Application for Subdivision and Site Review

_____ Subdivision _____ Site Plan
 _____ Pre-Application Conference
 _____ Preliminary Plan Review
 _____ Final Plan Review
 X _____ Other: Revision request for previously staff approvals dated 11/04/2021
and 08/01/2023

Proposed Development Name: Sebago Solar

Previously Approved Plan

Job Number:
80930
 Drawing No:
C-3
 Sheet 4 of 8

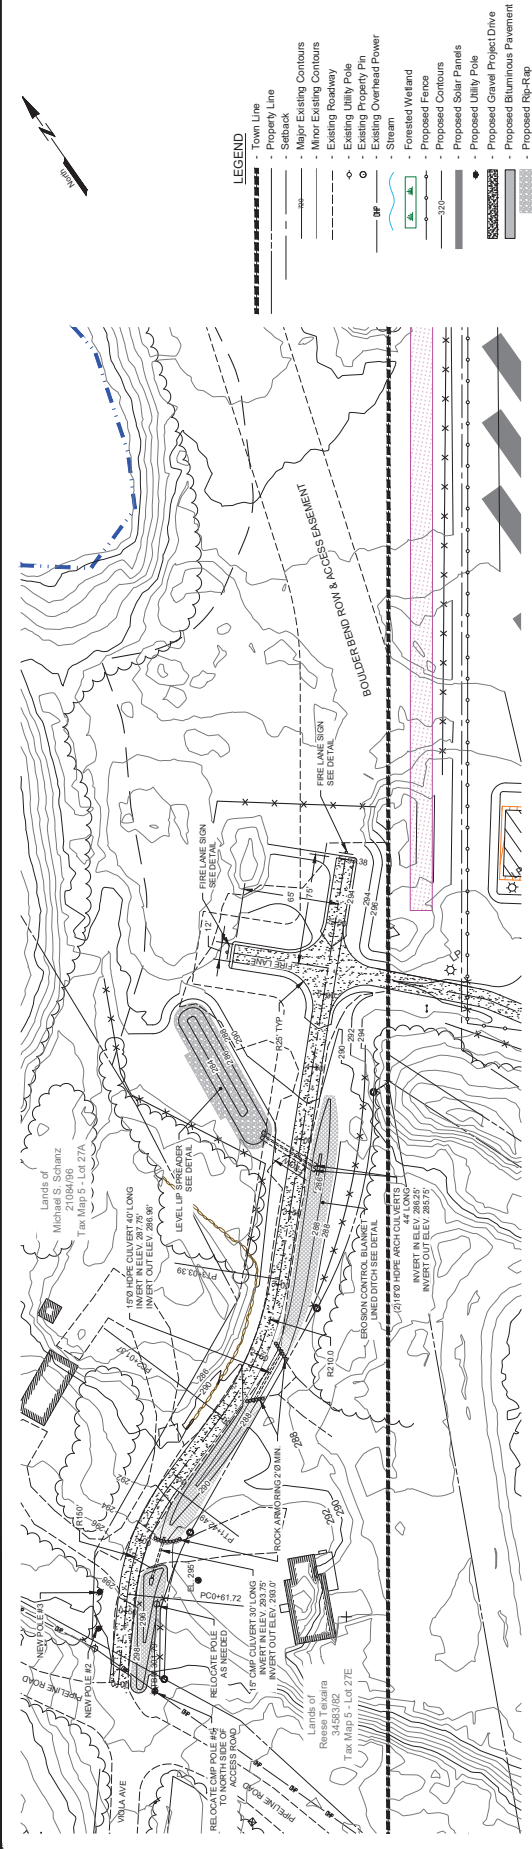
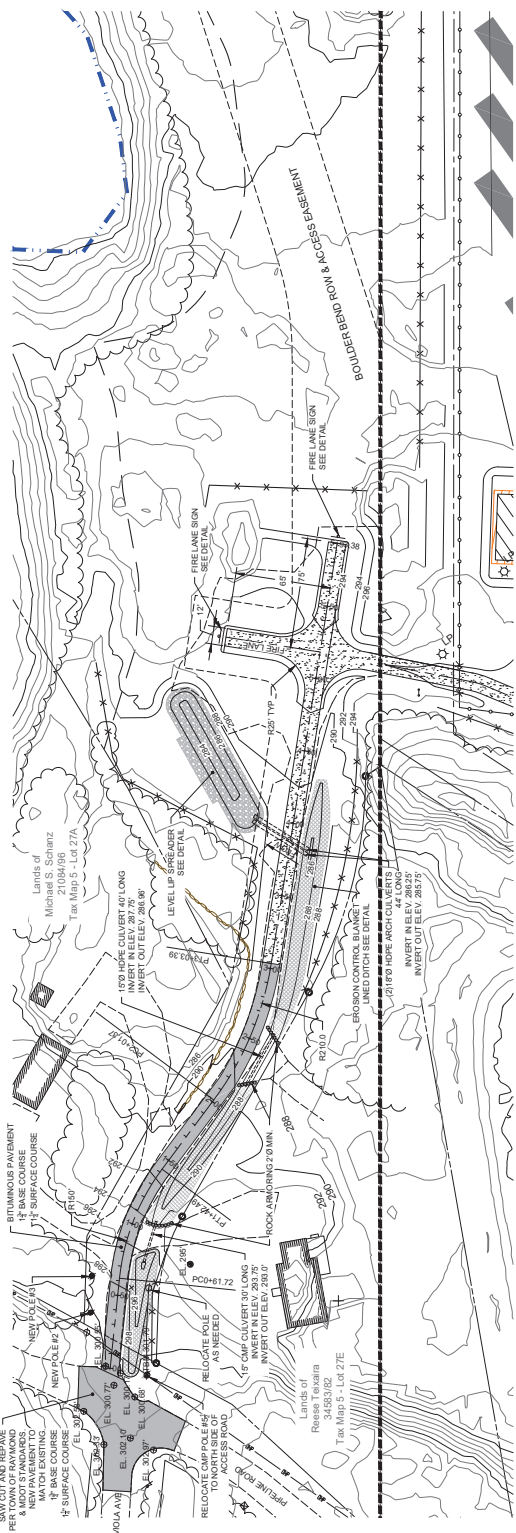
Revised Plan for Approval

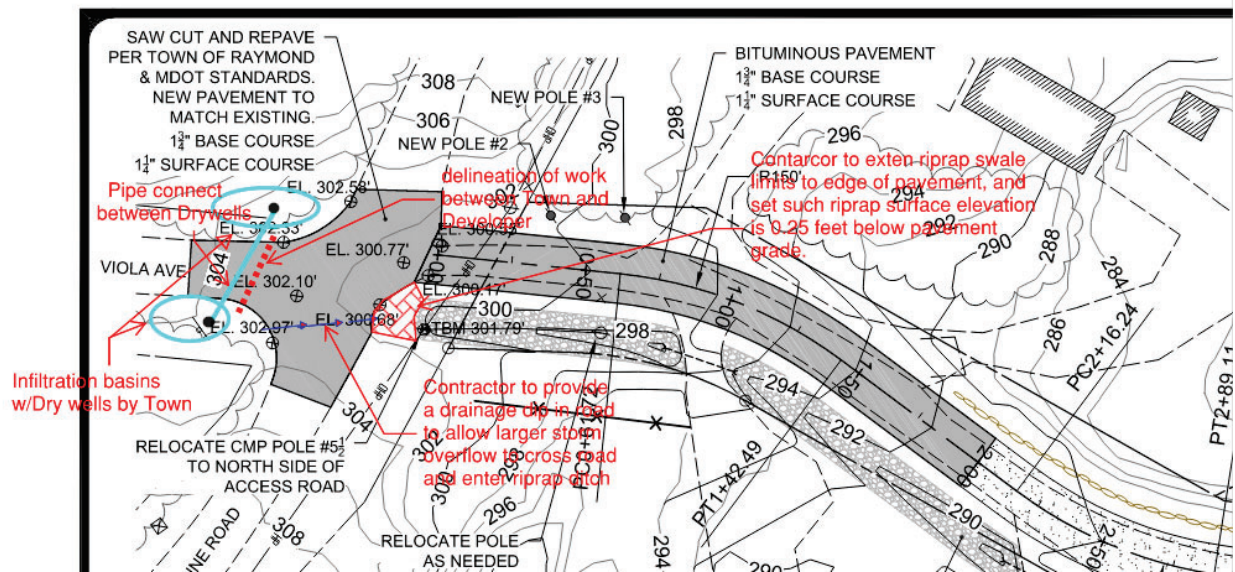
7/19/23 REVISION: The Intersection shall be paved and designed to accommodate potential surface drainage flood overflow. The Town will be installing drainage infiltration measures to accommodate runoff traveling down Viola Avenue. The applicant shall extend stone ditch protection/riprap of their access road ditch to collect any flood runoff that may cross the intersection in an extreme flooding event. Below is a sketch of the areas and intent for the applicant/developer to provide.
